RE: Quality Fleet Services, Inc.  
Site Re-Development  
548 New Ludlow Road, South Hadley  
MassDEP #288-0436

The following information has been submitted to address the comments received from Aimee Bell Project Engineer of Fuss & O'Neill in a letter dated August 5, 2015 for the above referenced project:

## Stormwater Management Plan – Narrative

***PROJECT MANUAL &  
DRAINAGE REPORT***

**EXISTING WATERSHED**  
**QUALITY FLEET SERVICES, INC.**  
 548 NEW LUDLOW ROAD  
 SOUTH HADLEY, MA

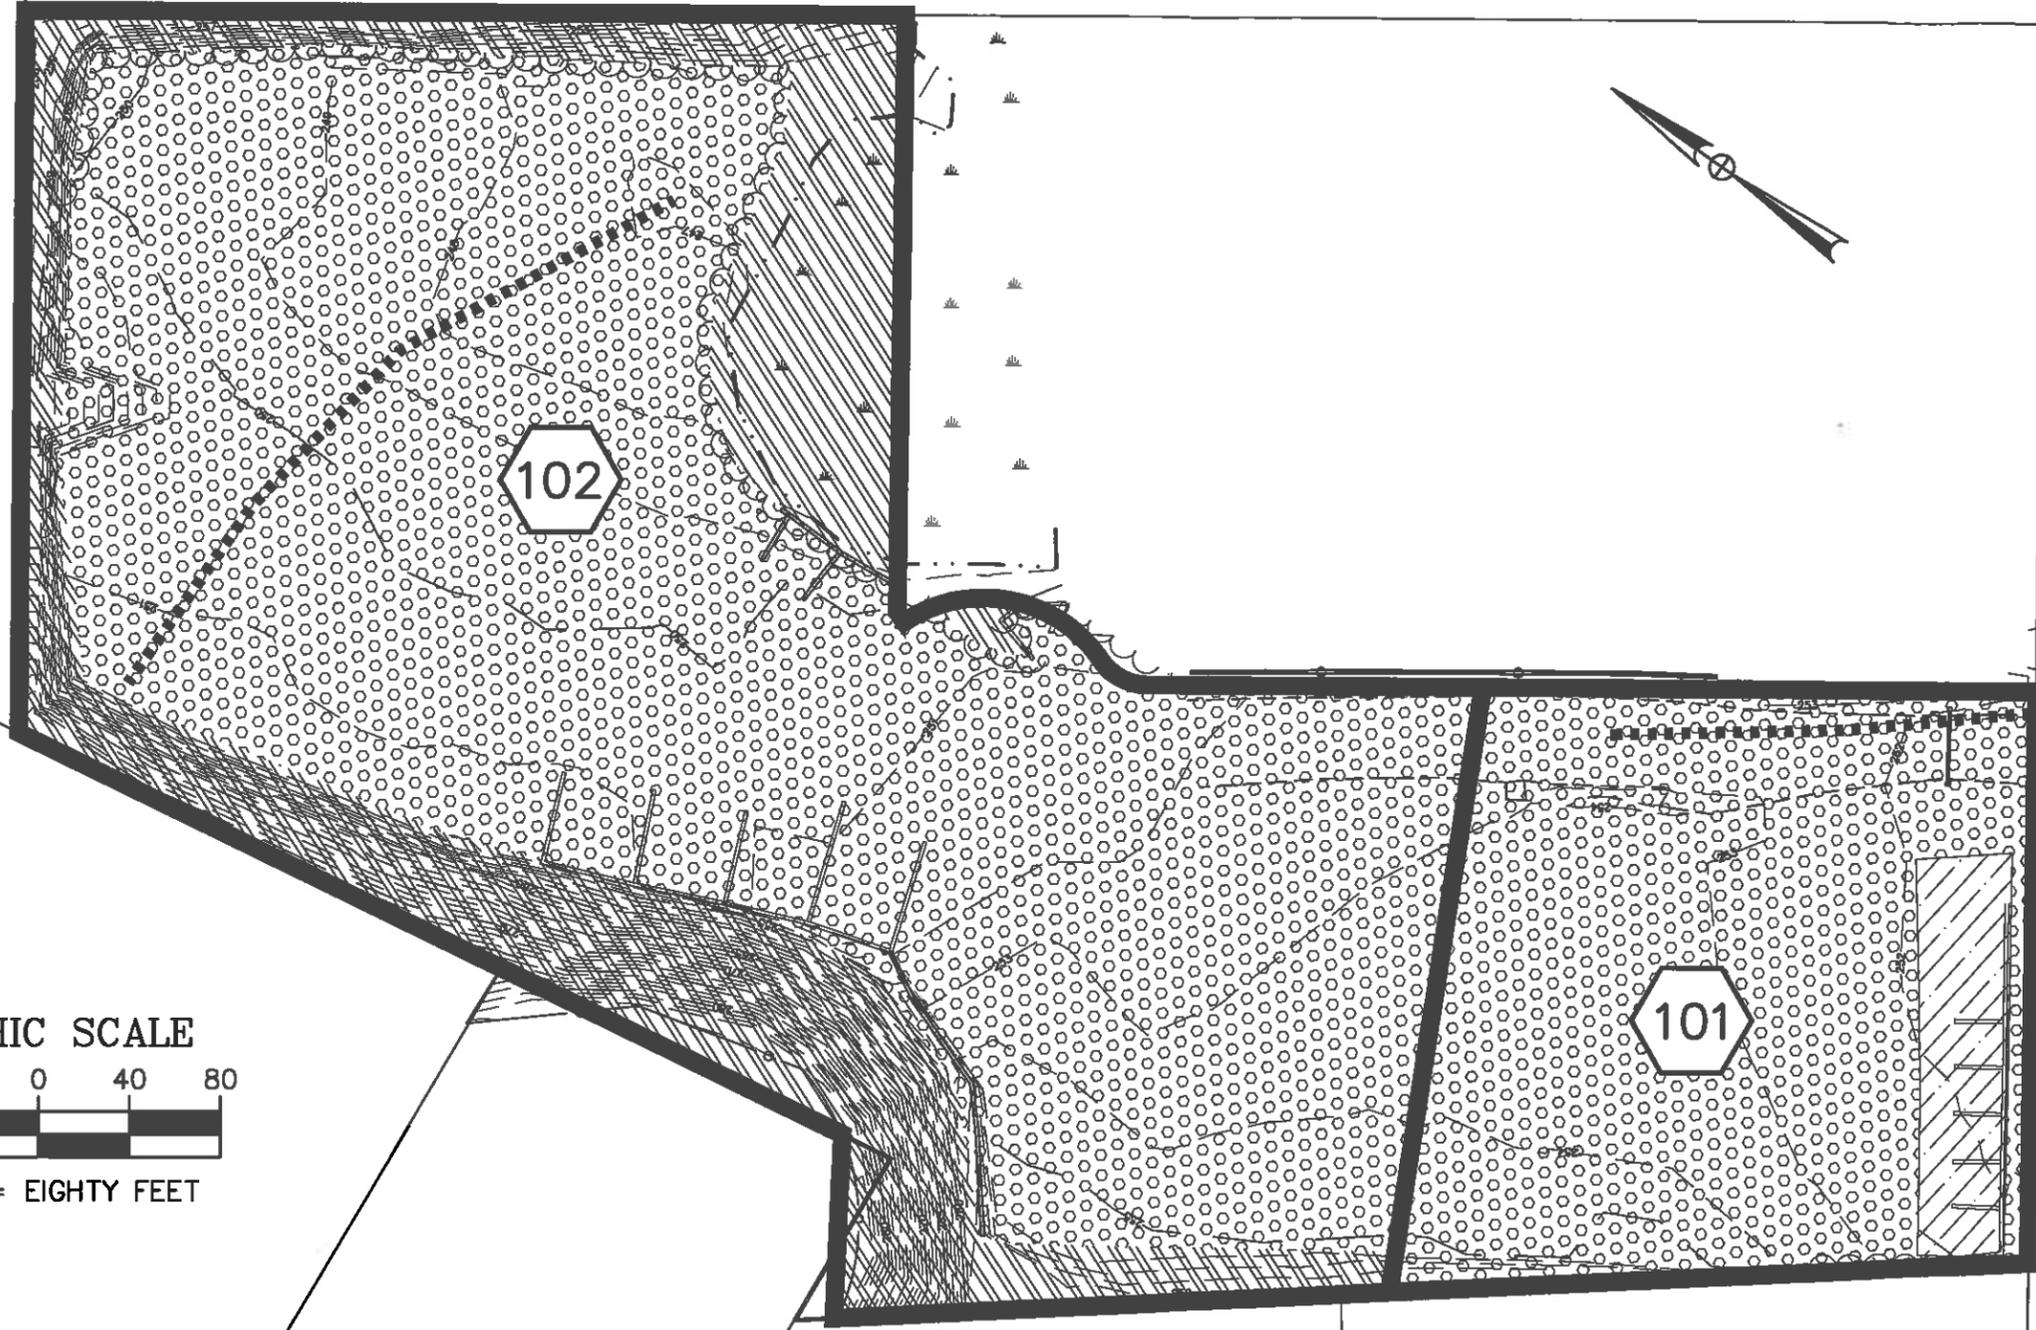
3. The existing watershed map and proposed conditions map have been revised to clarify the area converted to brush in the subcatchment area #201.

4. The existing watershed map and proposed conditions map have been revised to clarify the area converted to brush in the subcatchment area #202.
5. The existing watershed map and proposed conditions map have been revised to clarify the area of gravel in each subcatchment area.
